E3615A-02-S

S E R V I C E N O T E

E3615A 60W Lab Bench DC Power Supply

POSSIBLE SHOCK HAZARD

3**REMOVE COVER**

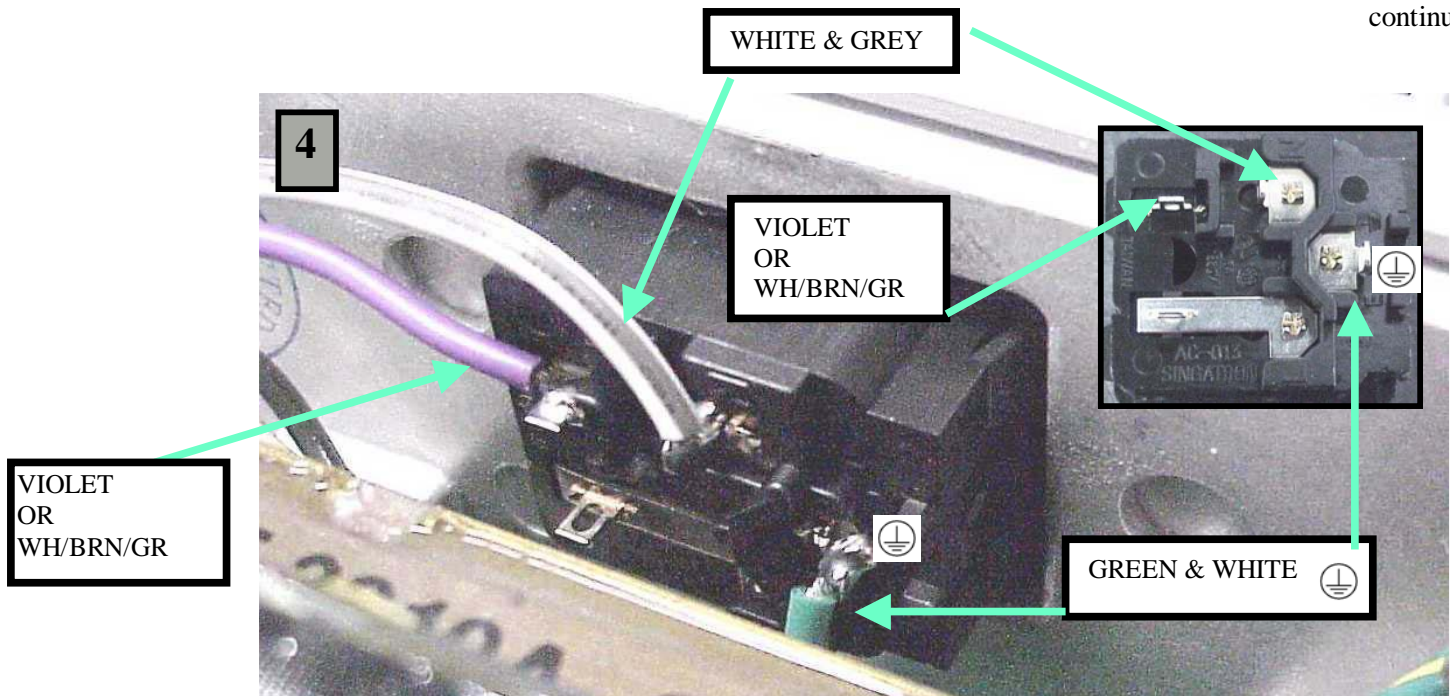
**CAUTION: TEST FOR LOOSE AC MODULE**

1. Make sure linecord is removed from outlet.
2. With linecord securely inserted in AC Module as shown, pull forcibly (2 times) in direction of arrow.

LOOSE AC MODULE

1. If the AC Module pulls out from Unit as shown it will need to be replaced.
2. If the AC Module remains in place it does not need to be changed. Put a mark on the AC input label in the lower left hand corner with indelible ink to indicate that the AC module has been checked. This label can be found below the AC module.

Pry Rear Bezel and Front Panel away from Cover in four places. Then lift Cover off unit.

Pry Tabs out on rear of Top Cover and lift Cover off of the unit

REPLACE MODULE with P/N 5065-6978. Before soldering perform “TEST FOR LOOSE AC MODULE” as shown in picture above. This will confirm that the new Module is secure. Solder wires and **REPLACE FUSE**.

100/120 VAC input-	use Fuse P/N 2110-0702 (2 amps, 250 volts)	E3610/11/12/14/15/16/17/20A
100/120 VAC input-	use Fuse P/N 2110-0918 (1.6 amps, 250 volts)	E3630A only
230 VAC input-	use Fuse P/N 2110-0599 (1 amp, 250 volts)	E3610/11/12/30A
230 VAC input-	use Fuse P/N 2110-1346 (1 amp, 250 volts)	E3614/15/16/17/20A

CAUTION: WIRING MUST BE CORRECT OR H_⊥ TSINK COULD BE AT LINE POTENTIAL.

CAUTION: MAKE SURE SAFETY GROUND IS ATTACHED TO HEATSINK
